PRODUCT/PROCESS CHANGE NOTICE (PCN)

PCN #: SR-0210-03 DATE: 27 Oct 2002 Product Affected: TSOP (PH44) product in Trays Date Effective: 27 Jan 2003	MEANS OF DISTINGUISHING CHANGED DEVICES: <input type="checkbox"/> Product Mark <input type="checkbox"/> Back Mark <input type="checkbox"/> Date Code Tray manufacturer changed <input checked="" type="checkbox"/> Other From " Kostat " To " Daewon "
---	---

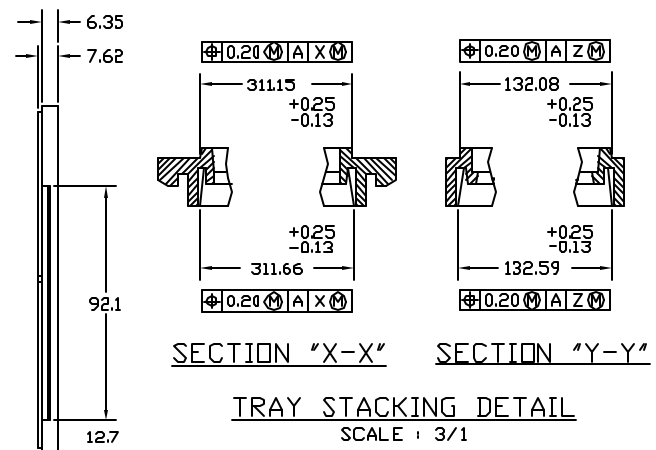
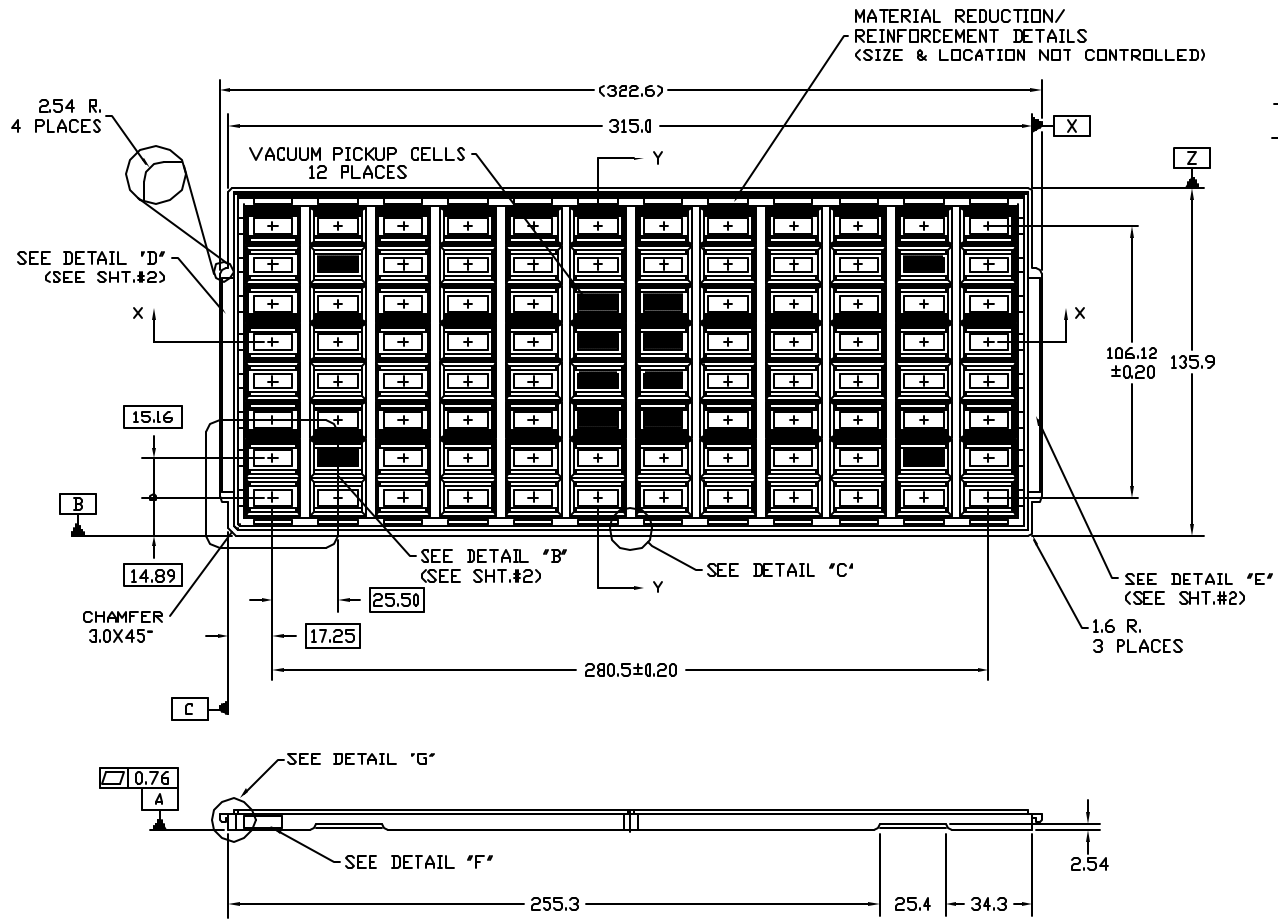
Die Technology To change the shipping quantity for TSOP (PH44) product in trays. Trays are compliant to JEDEC 95 standards. Tray size (outside dimensions) will remain same.
 Wafer Fabrication Process
 Assembly Process
 Equipment
 Material
 Testing
 Manufacturing Site
 Data Sheet
 Other - Shipping Tray

Description	Current Tray	New Tray
Drawing Number	MSC-1448	MSC-1738
Quantity per Tray	135	96
Pocket Size	13.67mm x 20.42mm	15.16 x 25.50mm
Tray Matrix (Qty.)	9x15	8x12
